**Constellation Energy**  
Generation Group

**SUBJECT:** Calvert Cliffs Nuclear Power Plant  
Unit No. 2; Docket No. 50-318  
Response to Preliminary Accident Sequence Precursor (ASP) Analysis for the  
Unit 2 January 2004 Operational Event

**PRELIMINARY ACCIDENT SEQUENCE PRECURSOR ANALYSIS**

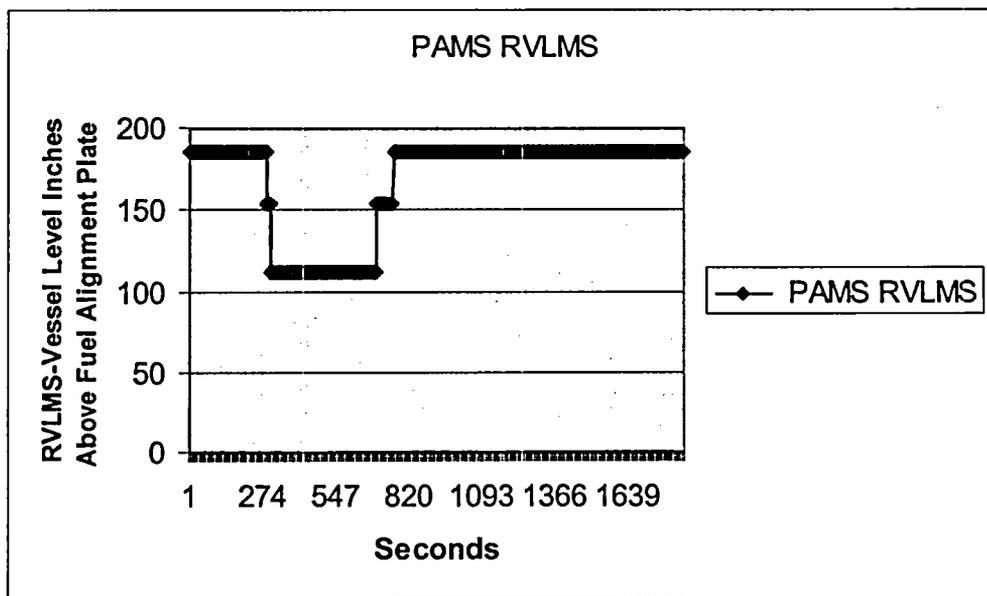
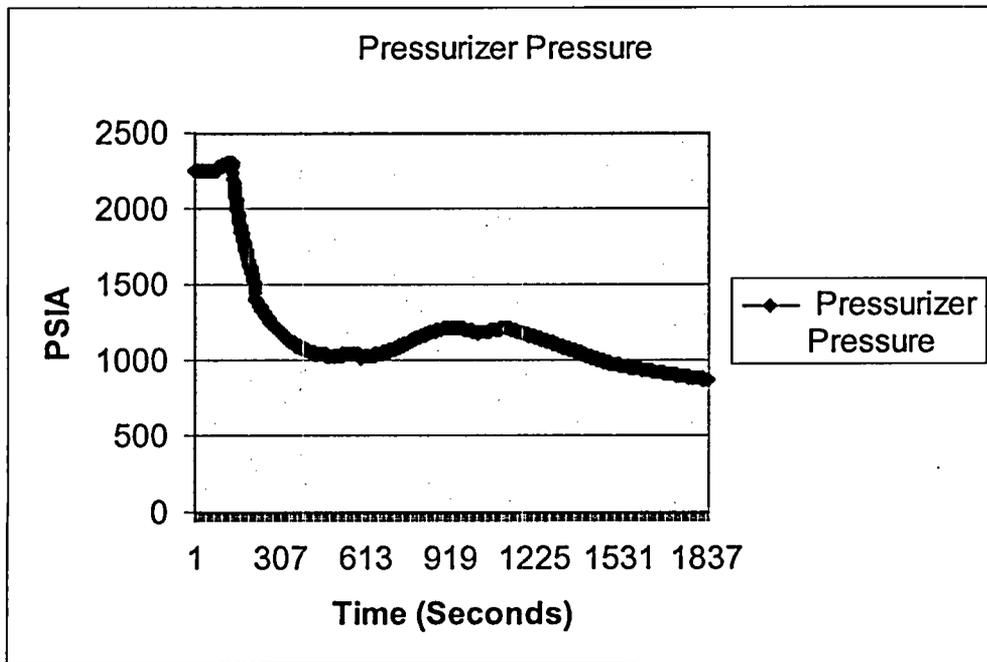
Given this, it is likely that the failure of both MSIVs to close would produce the largest time available to achieve OTCC. Conversely, if both MSIVs closed, this would provide the least time available to achieve OTCC. To determine the time available, the difference between the steam generators reaching -350" and core exit thermocouple (CET) reaching 560°F would have to be determined. The EOP bases state "...Core cooling must be initiated prior to CET temperatures reaching 560°F. This is because the RCS will reach saturated conditions during Once-Through-Cooling at about the temperature it was initiated. Saturation pressure for 560°F is approximately 1133 PSIA. Above this pressure, HPSI flow may not be sufficient for core cooling requirements..."

The RCS pressure prior to OTCC should not be used as the timing basis for OTCC. As can be seen from the EOP basis document, the RCS temperature should be used instead. In general, the lower the RCS pressure is prior to initiation of OTCC, the greater the likelihood that OTCC can be achieved.

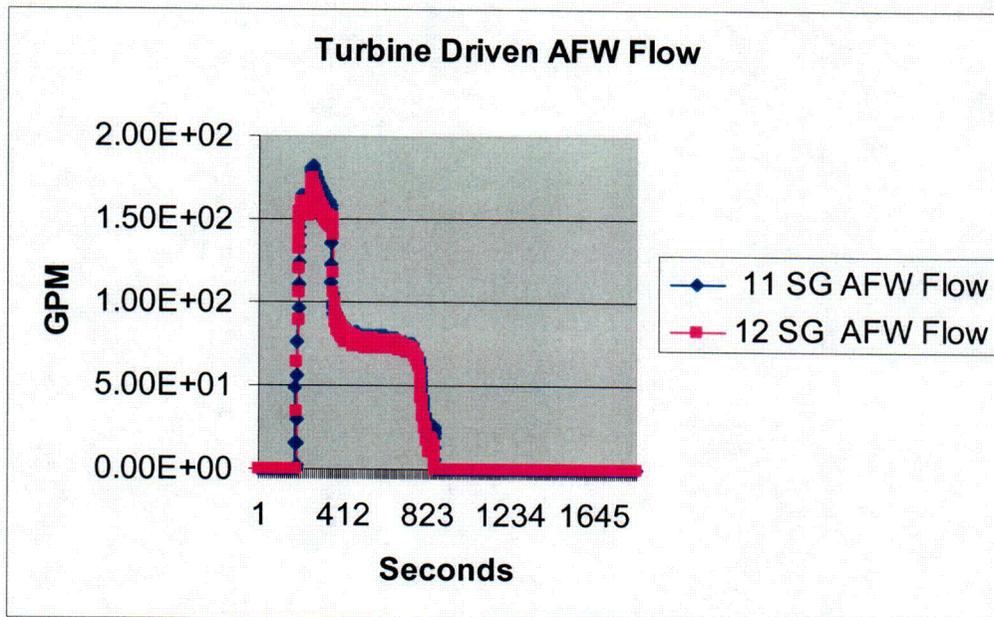
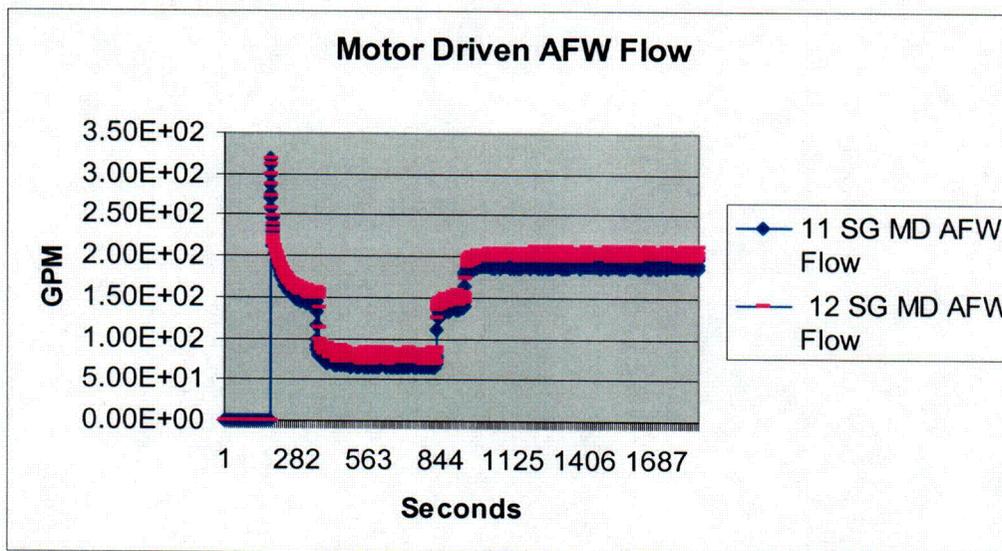
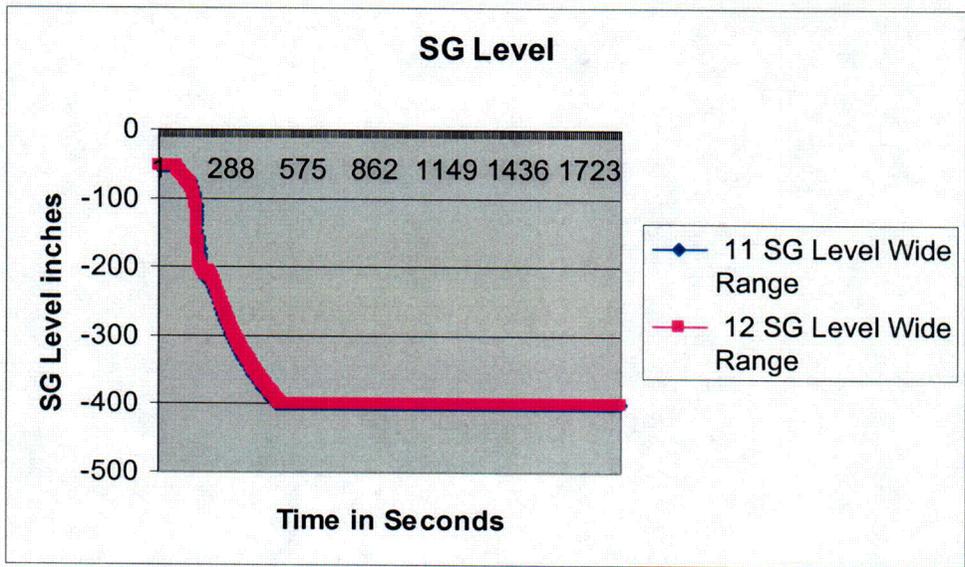
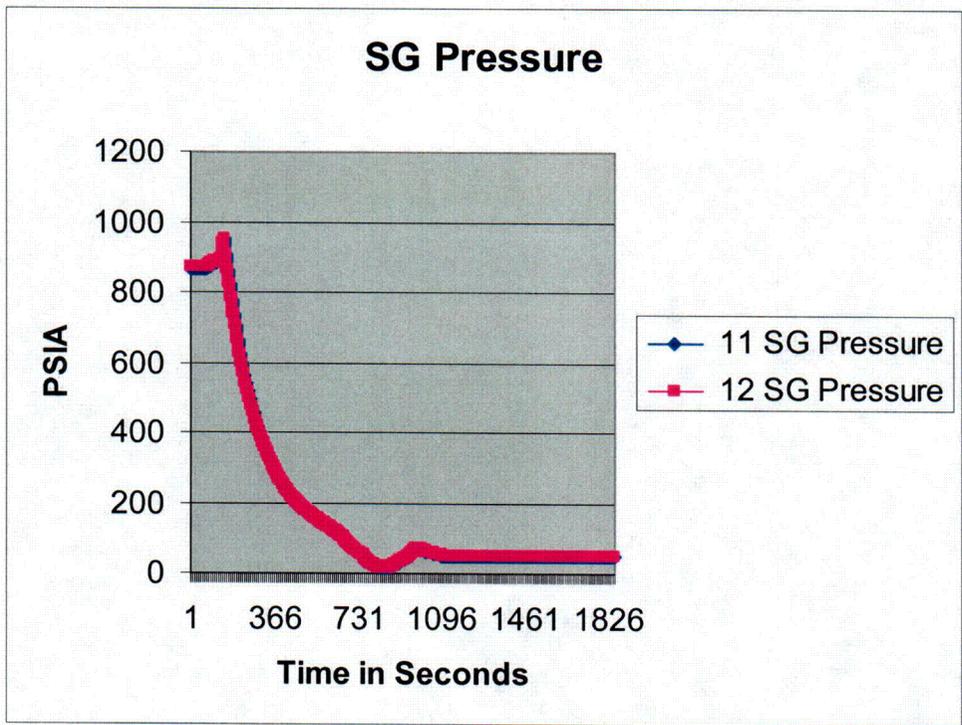
To illustrate the recovery possibilities available, we performed a simulator run with the quick open signal failing to clear AND with the MSIVs failing to close on an SGIS. Probabilistic risk assessment personnel walked through the Emergency Operating Procedures (EOPs) and discussed the operator actions expected in this scenario with Operations training personnel. The relevant graphs are attached. This includes the following parameters:

- Pressurizer Pressure
- Pressurizer Level
- T Cold [Reactor Coolant System (RCS)]
- Steam Generator Level and Pressure
- AFW Flow (Motor- and Steam-Driven)
- Reactor Vessel Level Monitoring System – Vessel Level

1. An AFW Block was not initiated as both steam generators decreased in pressure at the same rate. [Note that an Auxiliary Feedwater Actuation System (AFAS) Block did not occur during the actual event. Even if one had occurred there are relatively simple recoveries to restore AFW after a block signal.]
2. The turbine-driven AFW pumps functioned until steam pressure dropped to approximately 50 psia in the steam generators and they were secured at this point.

3. Significant HPSI flow occurred into the RCS. This is evidenced by pressurizer level increasing at the lower temperatures and by observation of HPSI flow in the simulator. High pressure safety injection flow was not recorded in this simulator run.

4. The reactor core was not uncovered. There was indication of lowering reactor coolant level as observed on the Reactor Vessel Level Monitoring System from the 5 minute to the 12 minute time frame. At the lowest point, there was approximately 7 feet of water above the active fuel.

5. The RCS temperature leveled out above 350 degrees Fahrenheit.
6. Pressure in the RCS leveled out at approximately 1000 psia. Pressure was controlled using operator actions to secure HPSI flow, charging flow, and pressurizer heaters. Auxiliary spray was also used to maintain pressure.

7. Auxiliary feedwater flow, using the motor-driven AFW pump, was maintained during the entire transient after AFAS actuation.
8. Condenser vacuum was lost approximately 12 to 15 minutes into the transient. This is based on an assumed time for the condenser air removal units to fail on loss of Service Water (due to SIAS actuation). Note that for purposes of simulation the TBVs remained open.
